Clarification: Tender Number PROC-FE/CB/P&P/KPD-4507-A/2020

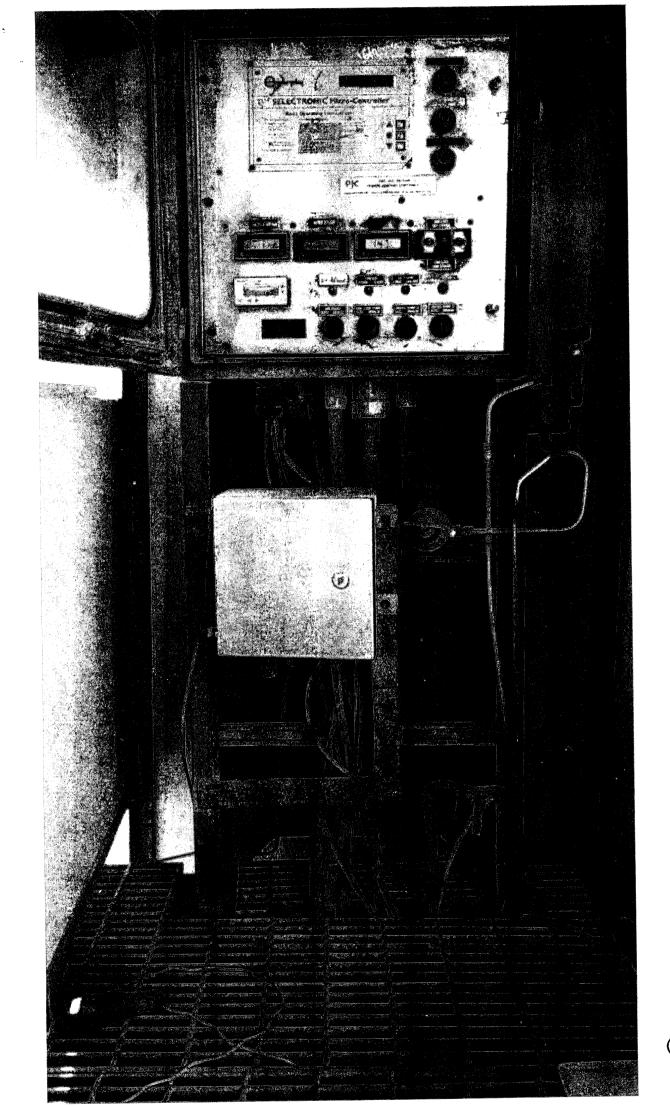
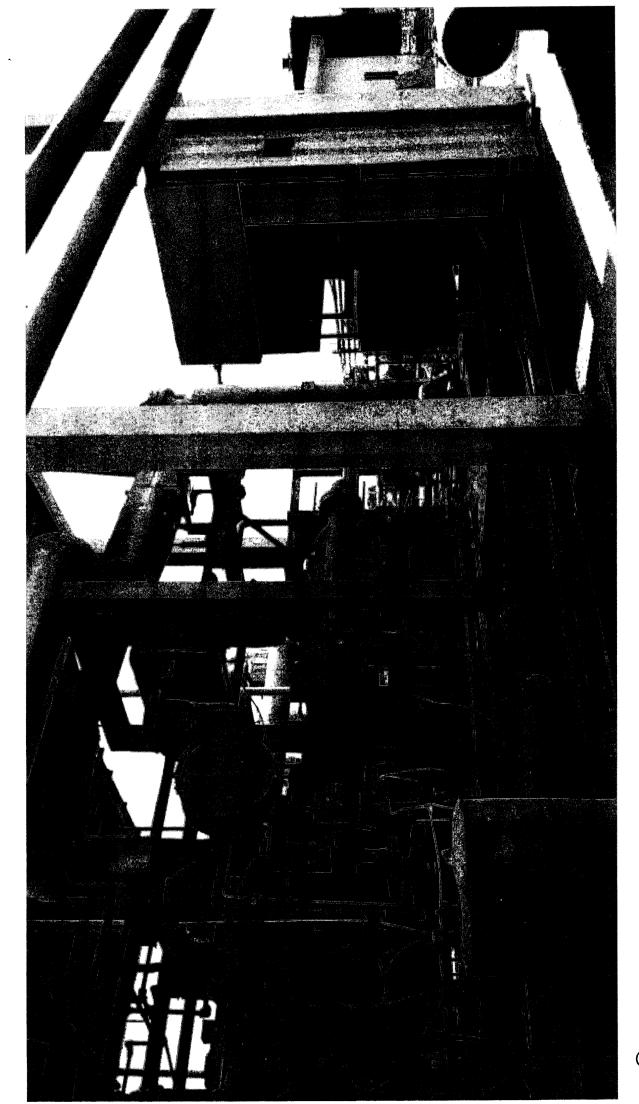
Bidder Query: Please confirm and provide the details Name Plat picture (Valve & Actuator) of installed SDV?

OGDCL reply: Attached.

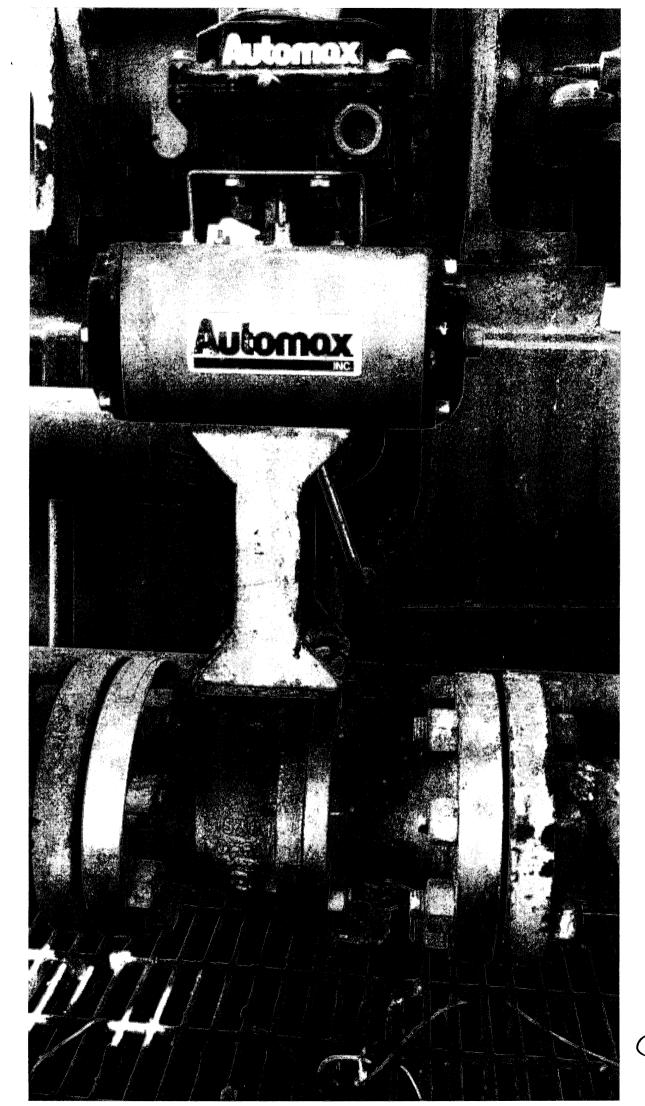
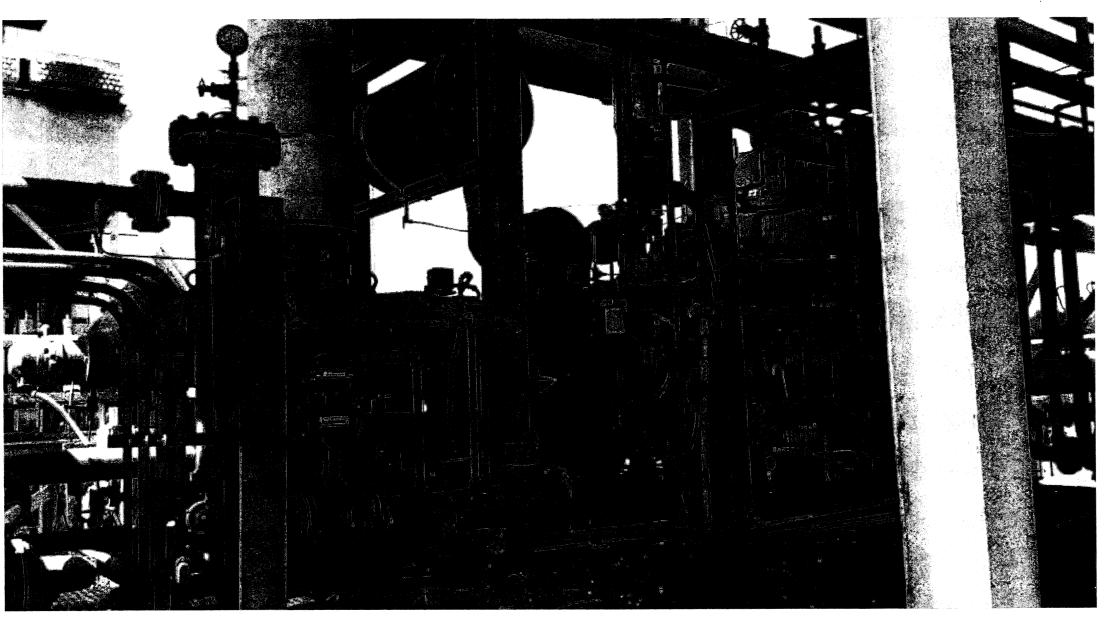
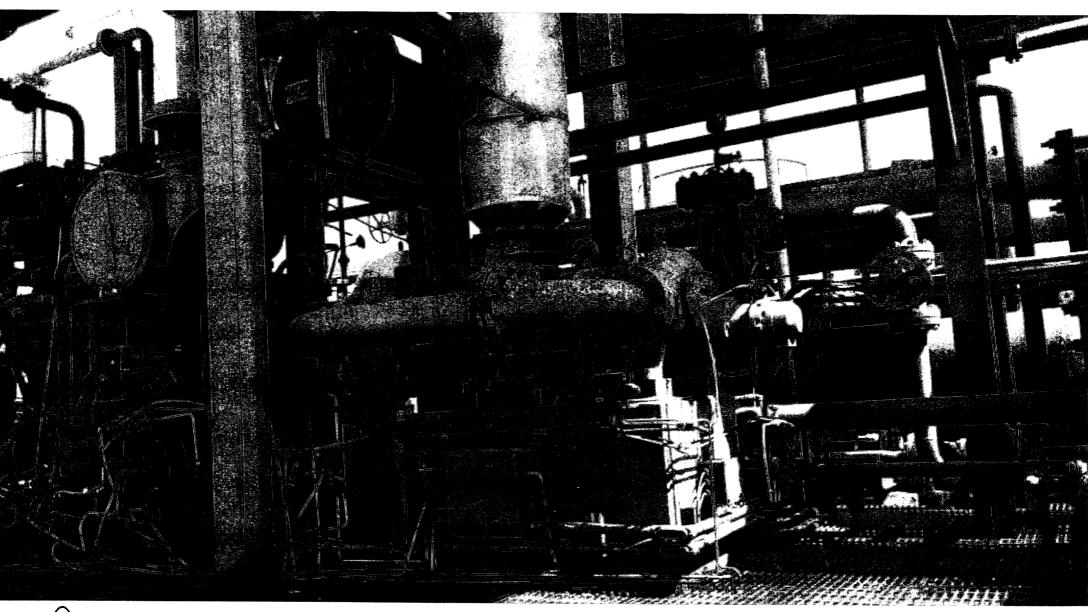
Bidder Query: For feedback signal, please confirm limit switches are installed or not? If installed, please share Data sheet / model of Limit Switch?

OGDCL reply: Limit switches are installed. Name plate data of limit switch attached.
